RE: *Comments from Hancock Associates: Franklin Heights Comprehensive Permit – Parcel B, Franklin, MA*

On behalf of Oliver Crossing Realty Trust, Guerriere & Halnon, Inc. has prepared the following information to address the comments contained in the letter from Hancock Associates dated March 16, 2022.

FRANKLIN HEIGHTS PARCEL B FRANKLIN MASSACHUSETTS

SHEET 1 OF 5 JOB NO. F4471

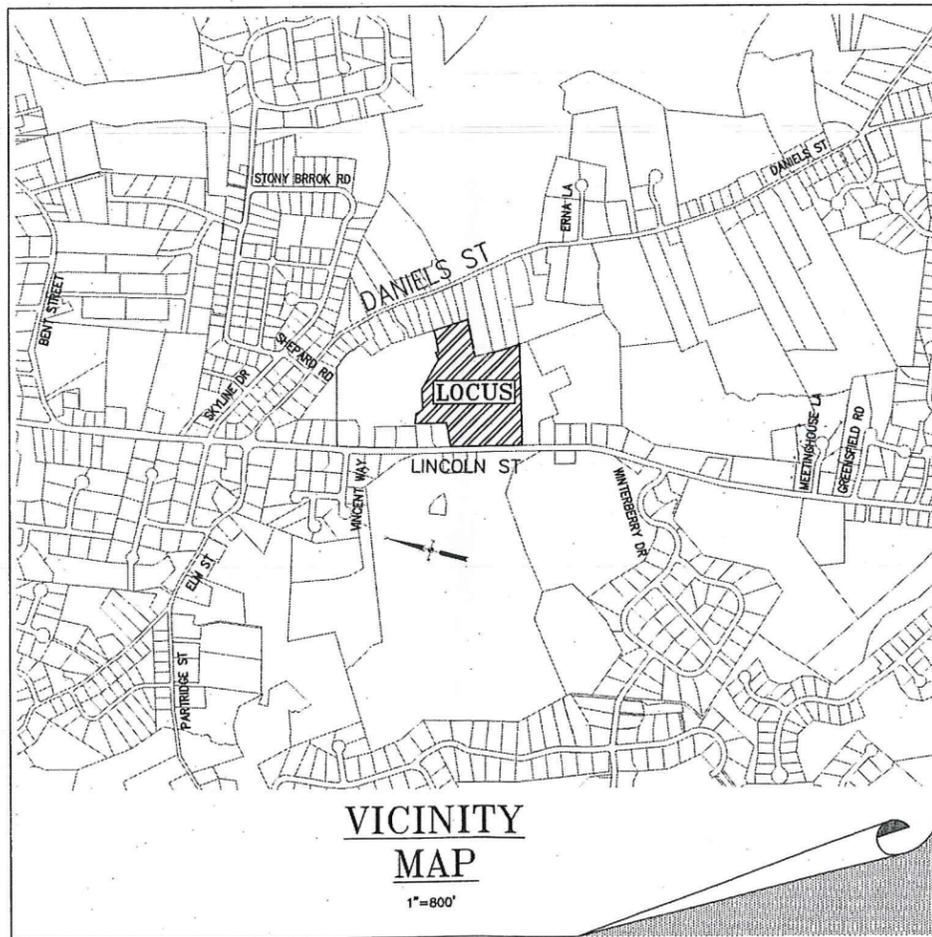
Z1: *The plans should be revised to detail zoning compliance and list requested waivers from the Franklin Zoning Bylaw.*

Z2: *The plans should be revised to enumerate parking required and provided.*

U3: The Applicant should provide water demand and projected sewer flows.

GH: Plans have been revised accordingly. See Sheet 1 of 5.

GH: Plans have been revised accordingly. See Sheet 1 of 5.

GH: Plans revised accordingly. See Sheet 1 of 5.

GRADING & UTILITIES

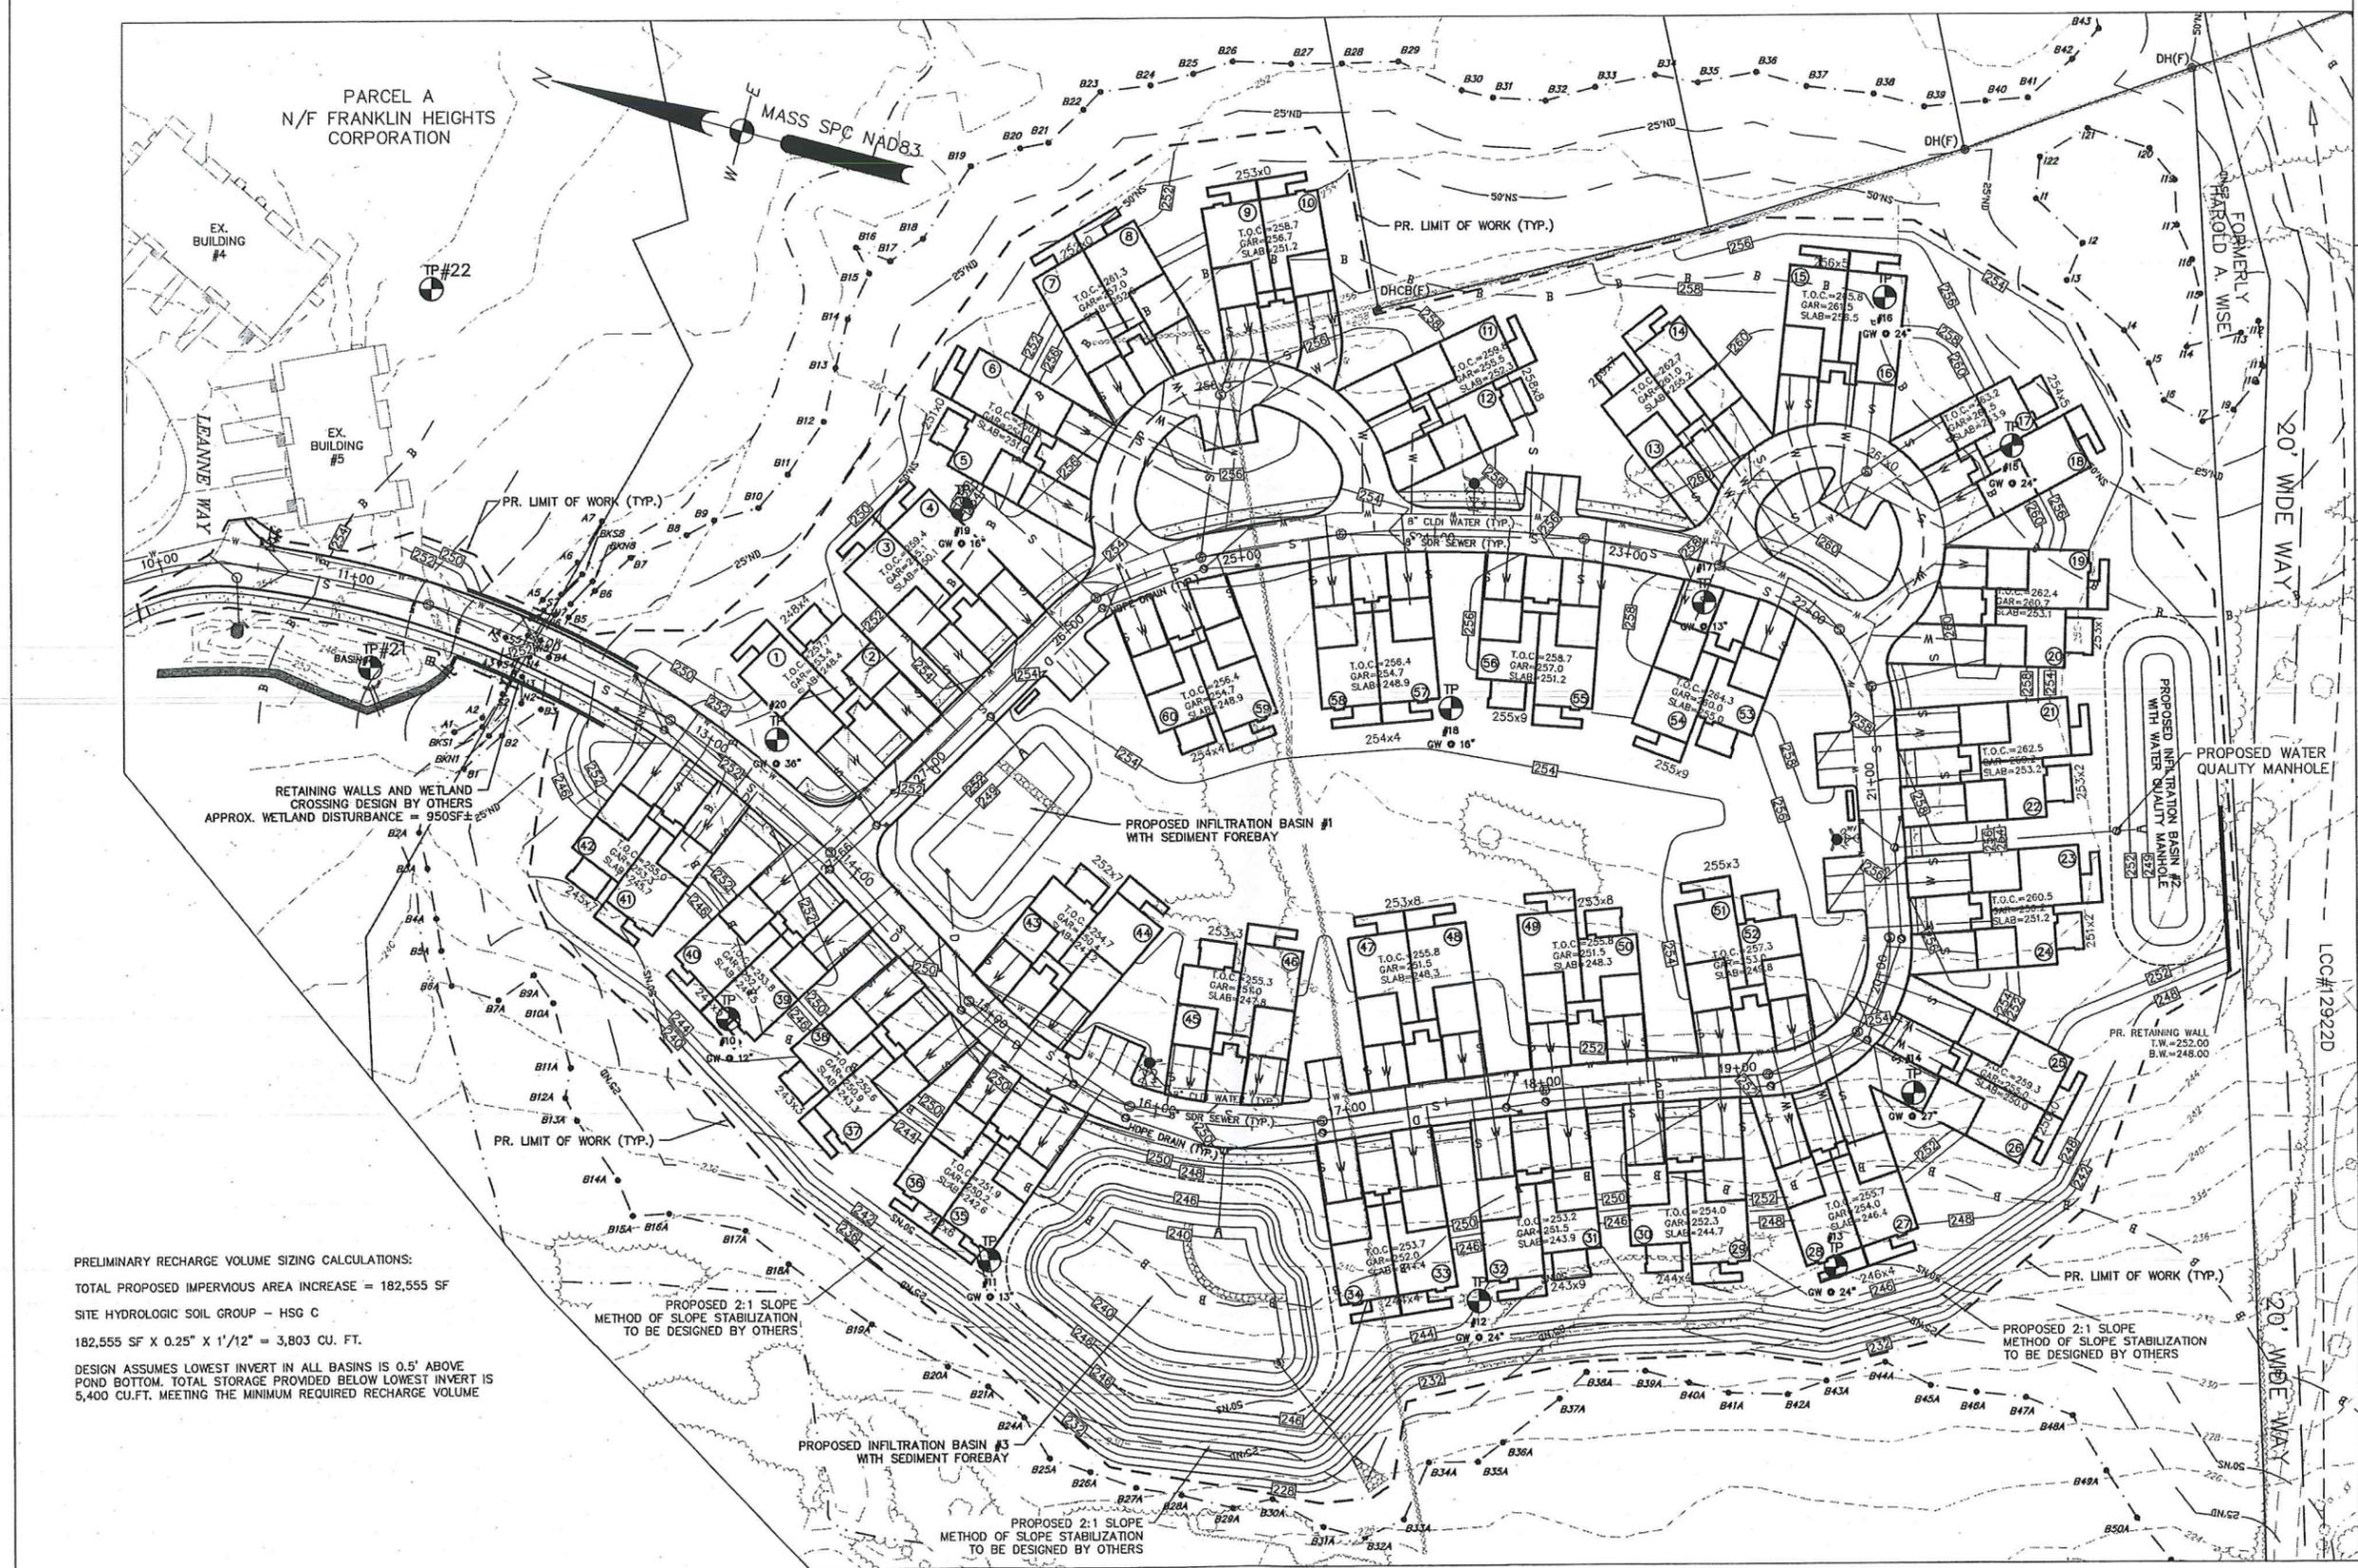
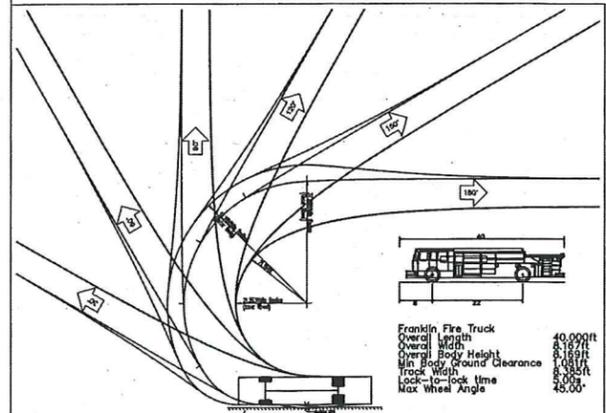
S2: *The Drainage Summary notes that stormwater treatment will be achieved through the use of proprietary hydrodynamic separators. The Applicant's Engineer should add the location of these separators to the Preliminary Plan and in the future provide make and model information and full supporting calculations.*

S4: *The Applicant's Engineer provided information in his 3-4-22 email, regarding the required recharge volumes based on soil mapping to be 3,500 cubic feet, stating this requirement was being met in the storage volume of 5,400 cubic feet below the outlets of the three basins. The Applicant's Engineer should add sufficient detail to the Site Plan confirming this information.*

U1: The plan should be revised to depict water line size and material.

U2: The plans should be revised to show separate sewer and water connections to the units.

GH: The location of the water quality unit has been added on Sheet 4 of 5. Make and model information, including full supporting calculations will be provided as the project progresses.

GH: Information has been added to Sheet 4 of 5 as requested.

GH: Plans revised accordingly. See Sheet 4 of 5.

GH: Plans revised accordingly. See Sheet 4 of 5.
